January 5, 2007

Subject: Perimeter Berm Stability
Crow Lane landfill
Newburyport, Massachusetts

You requested that we provide a review and recommendations for impacts on the design resulting from the change in berm materials.

Summary of
Stability Analyses

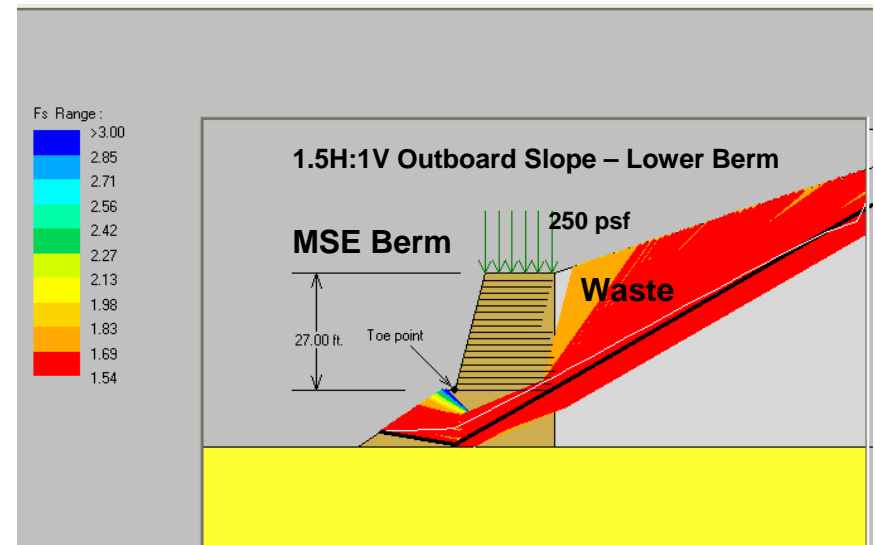
Minimum acceptable factor of safety values of 1.3 and 1.5 were adopted for global stability and bearing capacity failure modes, respectively, in the analyses. To achieve this factor of safety we have flattened the slopes to 1.5H:1V. The geometry is restrained by the proximity of the wetland and property boundary at the toe of the slope, and the already placed waste at the crest of the slope. In most locations it is not feasible to construct the entire berm height at the 1.5H:1V slope. We therefore steepened the upper portions of the berm using Mechanically Stabilized Earth (MSE) construction. In MSE construction geosynthetic reinforcement is placed in layers and is used to provide a reinforcing tensile force to improve the factor of safety.

The attached figure presents a summary of the design and analysis. The elevation of the toe point of the MSE portion of the berm corresponds to the existing berm elevation on the site. This elevation varies around the perimeter of the landfill. The analysis shown in the attached figure represents the location where the berm height is the greatest. The figure shows potential slip zones thru the berm, color coded with the factor of safety. The red zone indicates the most critical zone of sliding. The minimum factor of safety of the berm shown in the figure is 1.34.

1. Continuing to fill at a slope of 1H:1V will not meet the minimum acceptable factor of safety.
2. The existing berm slopes should be flattened to a 1.5H:1V to meet the existing height of the berm. We understand that in some locations and where the berm heights are less than approximately 20 feet that 1.5H:1V slopes may not be feasible. At these locations we recommend that the slopes be buttressed using individually placed boulder rip-rap, with a maximum thickness at the base of the slope.
3. To complete the berm along the westerly side of the landfill from its existing height to the proposed final elevations, and meet the geometrical constraints, we recommend Mechanically Stabilized Earth (MSE) berms be constructed, as shown in the attached figure. MSE construction techniques are also recommended for the southerly berm which is currently designed for construction at a 1H:1V slope.

Notes: 1. Length of reinforcement = 22 ft. bottom/16 ft. top.
2. Ultimate strength of reinforcement = 4,000 lb/ft bottom 6 layers; 3,000 lb/ft top 12 layers [vertical spacing = 18 in.].
